THM 700-R4"UPDATE HANDBOOK"

INTRODUCTION THM 700-R4 (4L60) UPDATE HANDBOOK

The 1987 through 1993 THM 700-R4 transmissions were produced with many engineering design changes. These changes have affected nearly every part used in the 700-R4. This "Update Handbook" will explain each change, the reason for the change, the parts that are affected by the change and any parts interchangeability concerns created by the change. 1993 was the last year the 700-R4 transmission was produced and this manual will cover all changes up through and including the 1993 changes.

Figure 49

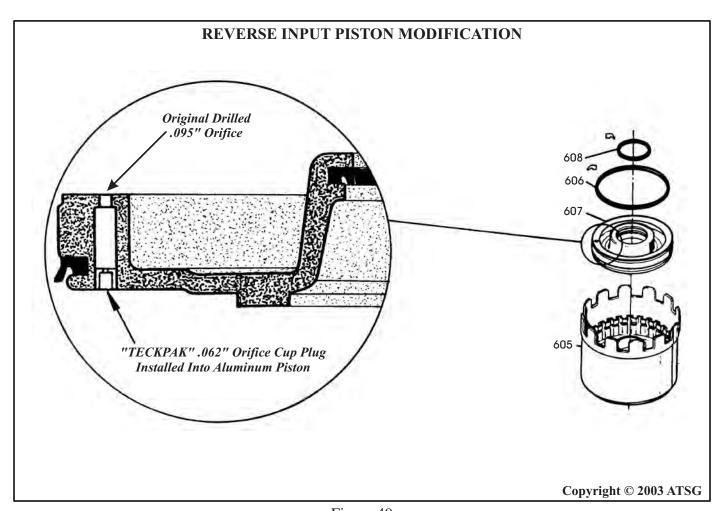
reverse input clutch piston, as shown in Figure 49.

design aluminum piston, as shown in Figure 49.

packages of 10, under their part number 77761C. This orifice cup plug should be installed into the back side of the piston, as shown in Figure 49. We recommend doing this procedure

Figure 51

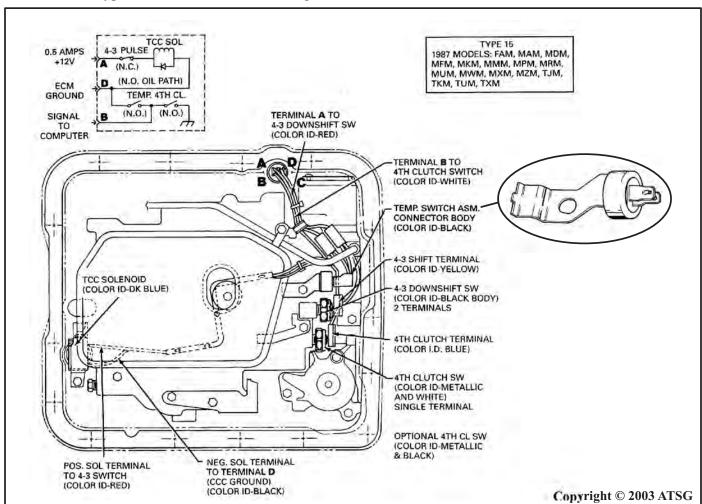
CHANGE: Beginning on June 28, (Julian Date 179) 1987, there was a new internal temperature switch that went into production on some models, as shown in Figure 51.

REASON: The new Temperature Switch mounts on the valve body and is submerged in transmission fluid in the oil pan, as shown in Figure 51. The temp switch supplies an alternate ground path for the TCC solenoid and applies the converter clutch when sump temperatures reach 125-135C (259-275F) and the transmission is in 4th gear.

- (1) TEMPERATURE SWITCH Added on the date shown above and mounts on the valve body, as shown in Figure 51.
- (2) INTERNAL WIRING HARNESS A new Type-15 solenoid and wiring harness assembly was need to accommodate the new temperature switch. The Type-15 wiring harness can be identified by a dark blue insulator and number 4415 cast into the top of insulator.

Cannot be used on any previous models and affects only the models listed in Figure 51.

Figure 53

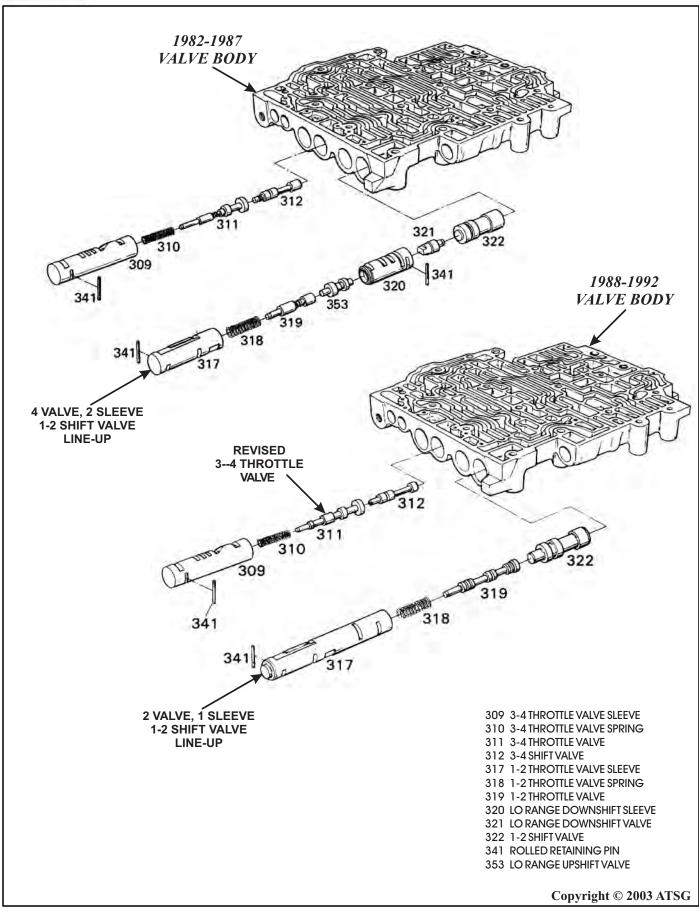
CHANGE: Beginning on July 23, (Julian Date 204) 1988, there was a new design valve body assembly with a revised 1-2 shift valve line-up, and a revised 3-4 throttle valve, as shown in Figure 53.

- (1) 1-2 SHIFT VALVE LINE-UP The 1-2 shift valve line-up changes from 4 valves and two sleeves, to two valves and one sleeve. The Lo Range Downshift Valve (321), Lo Range Control Sleeve (320), and the 1-2 Lo Range Upshift Valve (353), have been eliminated from the 1988 and later model valve bodies, as shown in Figure 53.
- (2) 3-4 THROTTLE VALVE The 3-4 throttle valve and sleeve now have revised diameters, as shown in Figure 53.
- (3) SPACER PLATE AND GASKETS Spacer plate and both gaskets have been revised to accommodate the changes in the 1-2 shift valve line-up, and also changes over the case bathtub where the number 9 checkball was eliminated, as shown in Figure 54.
- (4) NUMBER 9 CHECKBALL The number 9 checkball located in the bathtub in the case location shown in Figure 54, has been eliminated.

Figure 58

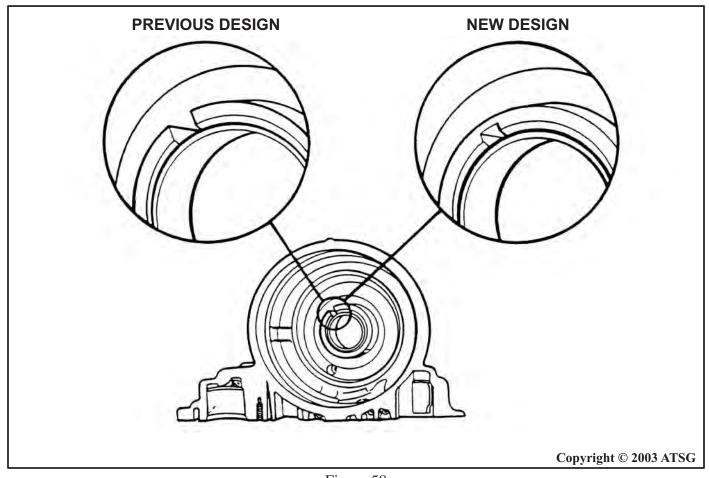
(1) TRANSMISSION CASE - The slot located in the case hub at the low/reverse clutch piston no longer extends through the hub, as shown in Figure 58. When servicing 1987 and previous model transmissions, it was possible to remove the snap ring with a screwdriver through the slot. With the new design case change, the snap ring *must* be removed with snap ring pliers.

The new design case can be used to back service any previous models.

Figure 59

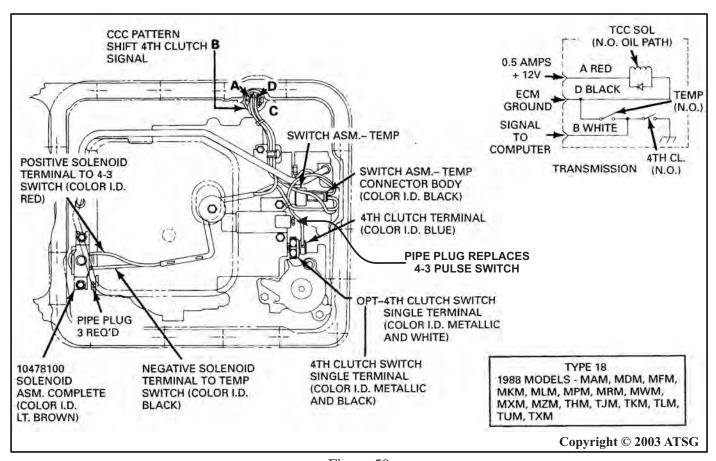
CHANGE: Beginning on May 10, (Julian Date 130) 1988, the 4-3 pulse switch located on the valve body was eliminated, which created a new Type-18 internal wiring harness, as shown in Figure 59. The new Type-18 internal wiring harness was implemented on only the models listed in Figure 59 and replaces the previous Type-15. Refer to Page 54 for illustration of the Type-15 internal wiring

- (1) VALVE BODY The 4-3 pulse switch was eliminated, and replaced with a pipe plug, as shown in Figure 59.
- (2) INTERNAL WIRING HARNESS Now becomes a Type-18 internal wiring harness with the wires required for the 4-3 pulse switch eliminated, as shown in Figure 59. The new Type-18 internal wiring harness can be identified by the solenoid insulator color, which is Lt. Brown and has 8100 cast into the solenoid insulator (See Figure 59).

Do not use the Type-18 internal harness assenbly on any previous models, as the ECM for these units is not programmed to take over the 4-3 pulse switch responsibilities.

Figure 61

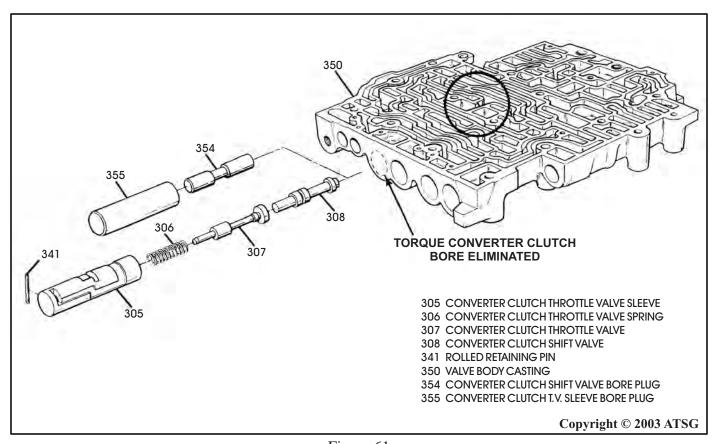
CHANGE: Beginning on November 15, (Julian Date 319) 1989, a new valve body assembly went into production on *all* models of the THM 700-R4 transmission, with the Torque Converter Clutch (TCC) bore eliminated, as shown in Figure 61. The converter clutch throttle valve was used on some previous models with Non-ECM controlled TCC apply.

(1) VALVE BODY ASSEMBLY - The TCC bore was eliminated and in place of the TCC bore, a notch in the worm track channeling now allows 2nd clutch oil into the TCC signal circuit. The notch is shown inside the circle in Figure 61.

According to General Motors, service valve body assemblies containing the converter clutch throttle valve and sleeve will continue to be available through your local G.M. dealer network.

Figure 62

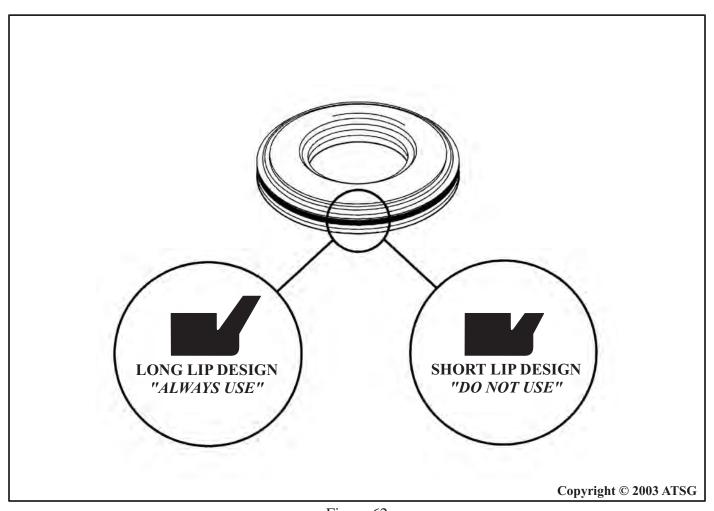
(1) INNER AND OUTER LIP SEALS - Changed to short lip seals on both inner and outer seals. This affected the 3-4 Clutch, Forward Clutch, Overrun Clutch and Reverse Input Clutch, as shown in Figure 62.

Our experience at ATSG has been that the short lip seals created durability concerns. Our recommendation is, "Always" use the Long lip seals. General Motors went back to the long lip seals during 4L60-E production in 1994.

Figure 63

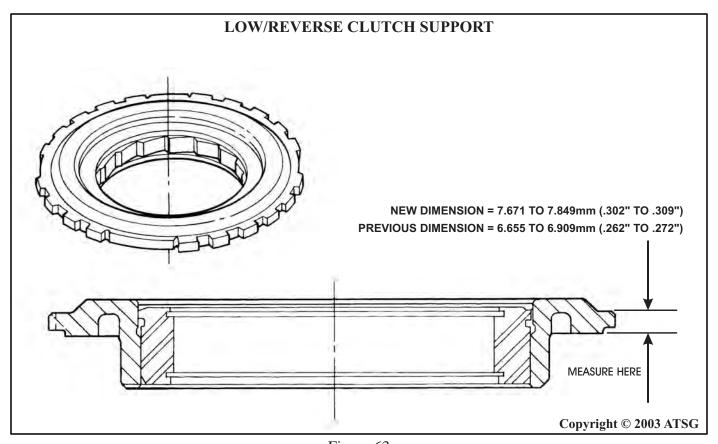
(1) LOW/REVERSE CLUTCH SUPPORT - Dimensional change which made it thicker in the area shown in Figure 63. There is no other means of identification except checking the measurement in the affected area. The new dimension and previous dimension are shown in Figure 63.

The new design thicker low/reverse clutch support and the new selective plates, when used as a service package, can be used to service units built from February 9, 1987, (Julian Date 040) through 1993 models.

The new design selective plates *cannot* be used with previous design level clutch support.

Figure 65

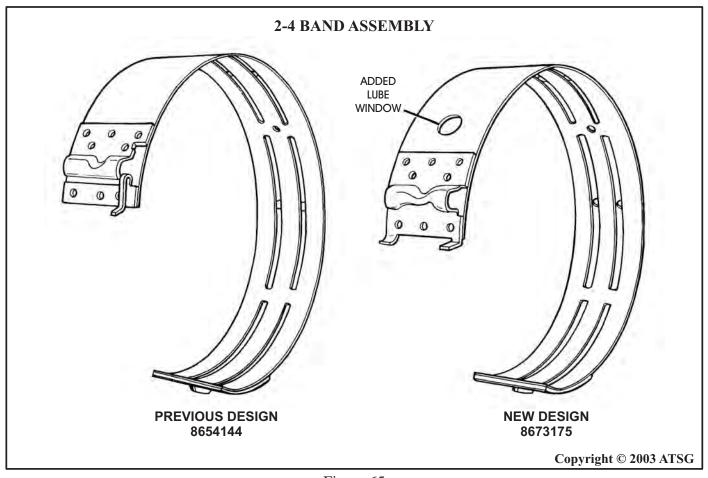
(1) 2-4 BAND ASSEMBLY - Changes to the 2-4 Band include modification of the apply and anchor brackets, locating tabs, and the addition of a lube window, as shown in Figure 65.

The new design band is interchangeable with the previous band and can be used to service all models 1982 through 1993.

Figure 66

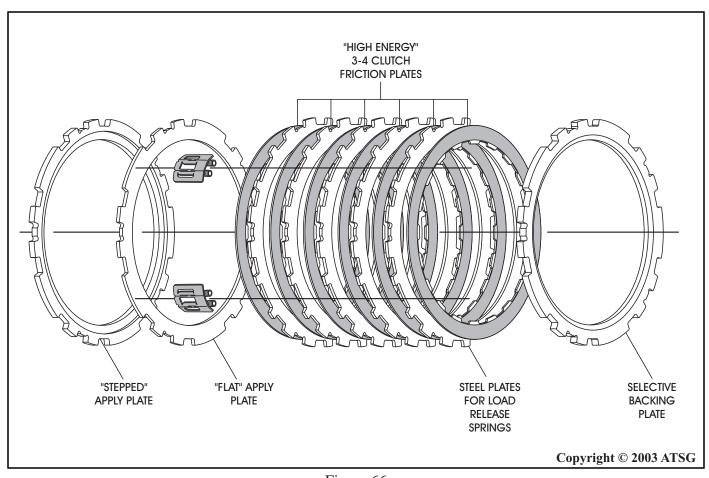
CHANGE: Beginning at start of production for 1991 models, new design 3-4 friction plates containing a "High Energy" friction material with increased heat capacity were implemented for *limited* applications, as shown in Figure 66. The 1991 models that recieved the new "High Energy" clutch plates were 1AMM, 1APM, 1CNM, 1CYM, 1FYM, 1KWM, 1LHM, 1RCM, RDM and 1YHM.

(1) 3-4 FRICTION PLATES - Manufactured with a high energy friction material to reduce slippage and thus increase 3-4 clutch durability (See Figure 66).

Do not use the new "High Energy" clutch material in any transmission that is not specifically calibrated to use it. If the new material is used in an incorrect application, shift quality will suffer and transmission damage can occur very quickly. The 1991 models that did not recieve the new material were 1AKM, 1DBM, 1CHM, 1CJM, 1FUM, 1KRM, 1RAM, 1WCM, and 1YDM. Careful inspection will also be needed during overhaul as the new clutch material looks as if it is burnt black, when in fact that is its normal color.

Figure 68

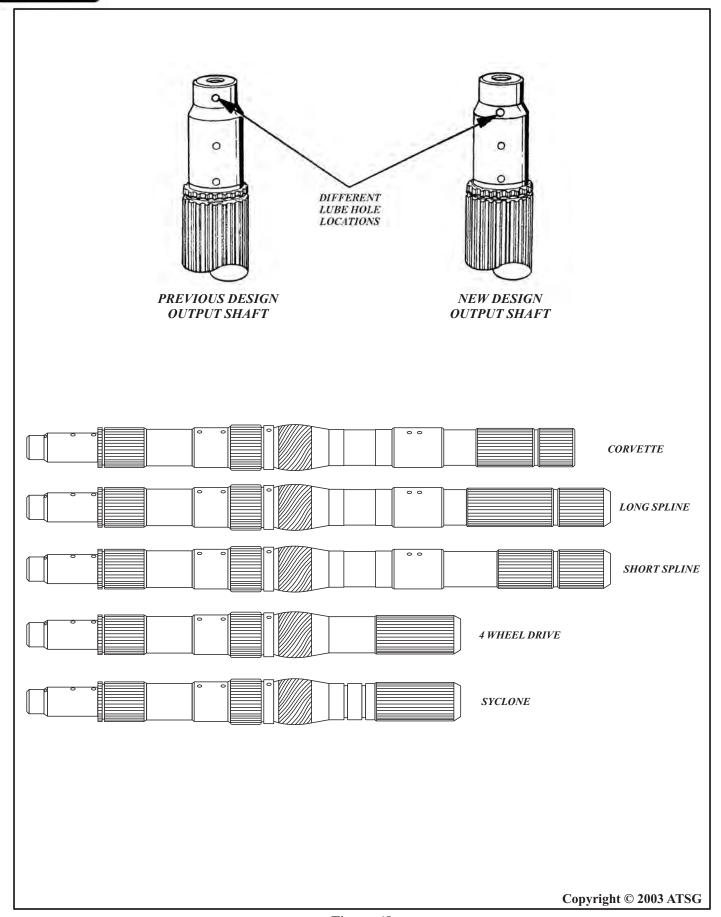
output shaft seal, as shown in Figure 67 and 68.

Figure 69

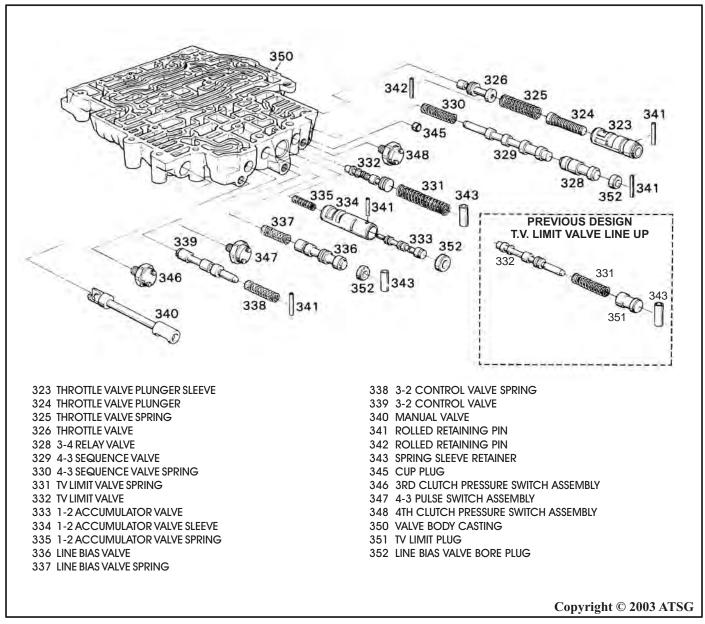
(1) TV LIMIT LINE-UP - The changes include a new design TV Limit Valve (332), a new TV Limit Valve Spring (331), and eliminates the TV Limit Plug (351), as shown in Figure 69. Both previous and new designs are illustrated in Figure 69.

The individual parts listed above *cannot* be interchanged between valve body castings. The new design valve body can be used to service models 1988 through 1993.
